Municipal Planning Commission Meeting
Thursday, July 16, 2026 at **6:00 PM**

- A) Discussion and public hearing on a preliminary plat for Grigsby Park, Phase 2, 6.9 Acres, 18 Lots, Zoned R-4 and Floodplain District (Urban Engineering, Inc., Applicant)

REPORT TO THE MUNICIPAL PLANNING COMMISSION

PRELIMINARY PLAT

SHEET C-1

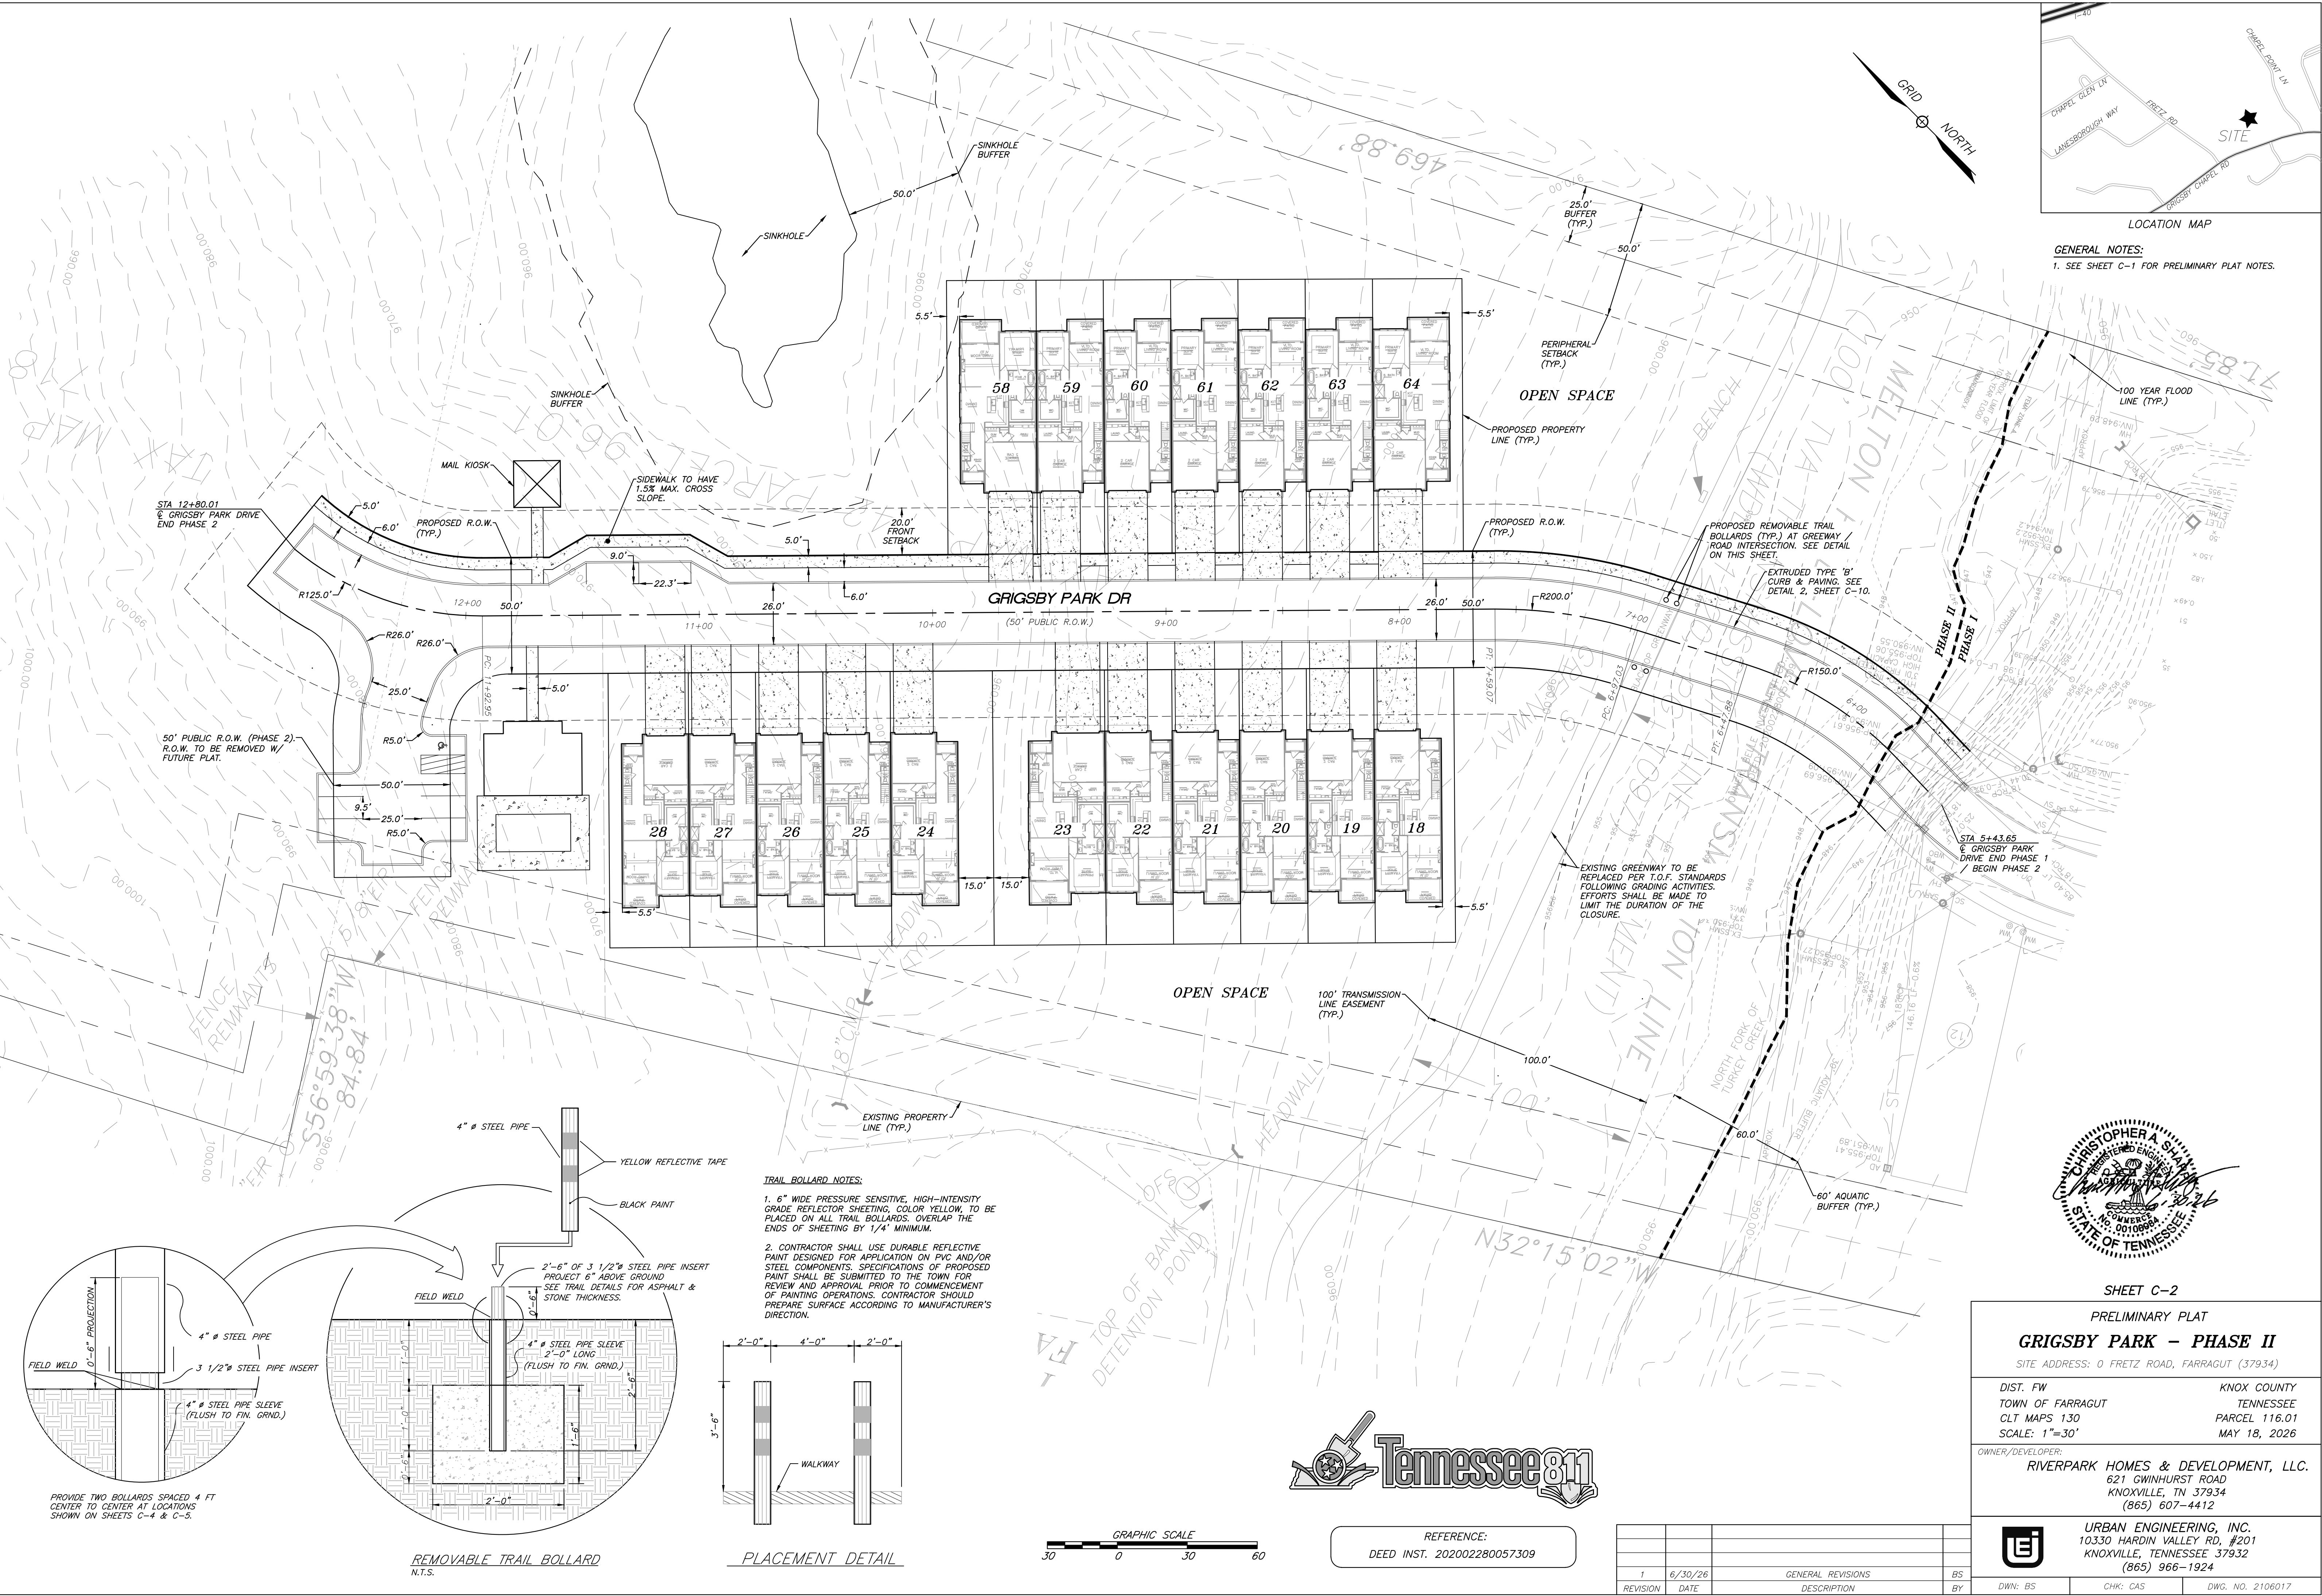
1. Please add a note to the plat that all units must have code-compliant sprinkler systems.
2. Please correct the street name to match the name included on the final plat of record.

3. Please provide signage and crosswalk markings where the road bisects both the sidewalk at the amenity area and the Grigsby Chapel Greenway. This can also help serve as required traffic-calming through either lane narrowing or a raised crosswalk cross-section.

4. Please modify Unit 28 so that it is not within the 50-foot peripheral building setback. A note is also needed to clarify that no portion of any building can be within the 50-foot peripheral building setback or the 50-foot building setback from the sinkhole lip elevation. Unit 58, for example, is very close to the 50-foot building setback from the sinkhole lip elevation.

SHEET C-6

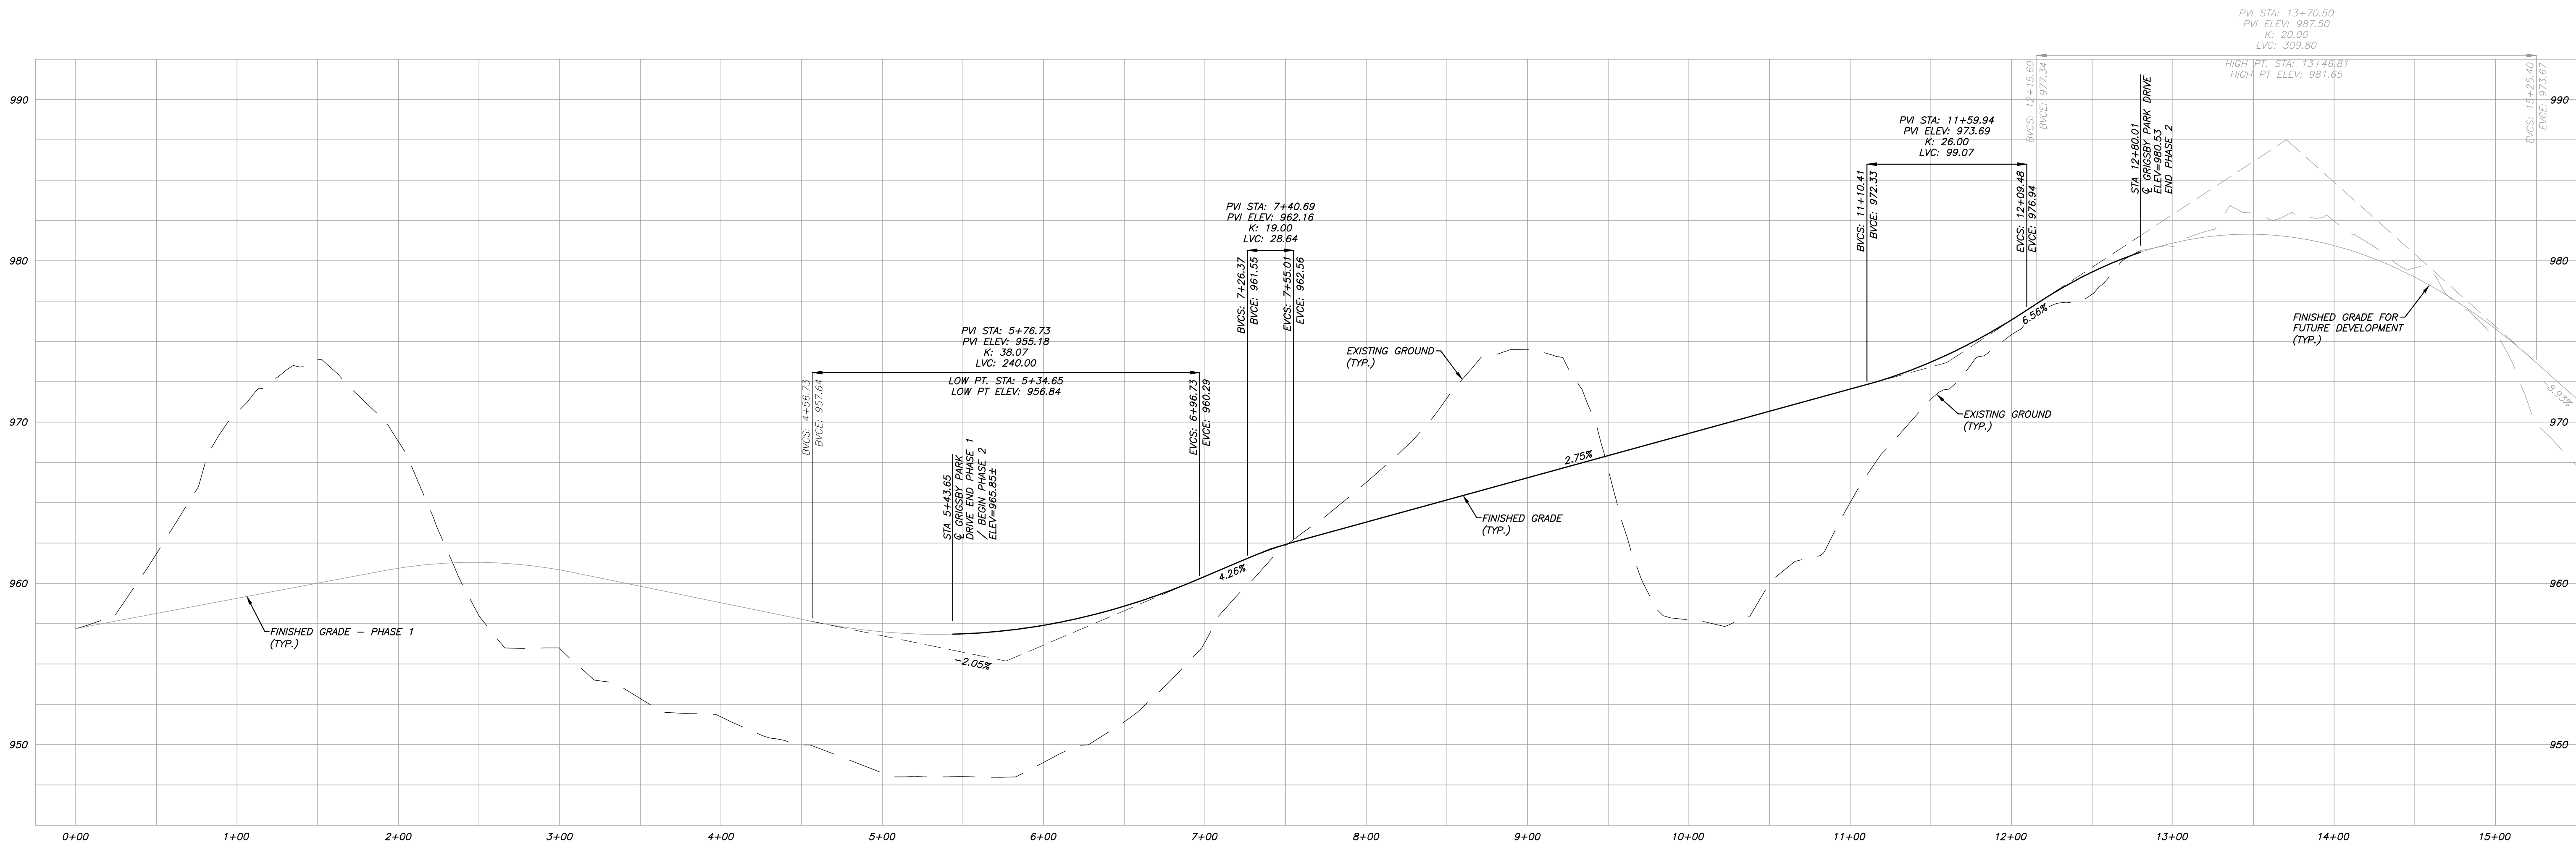
8. Please show storm sewer and associated structures on Sheet C-6.
9. FUD will ultimately need to sign off on the water and sewer sheets.
10. In the final stamped approved plan set, all utility sheets must be "for construction."
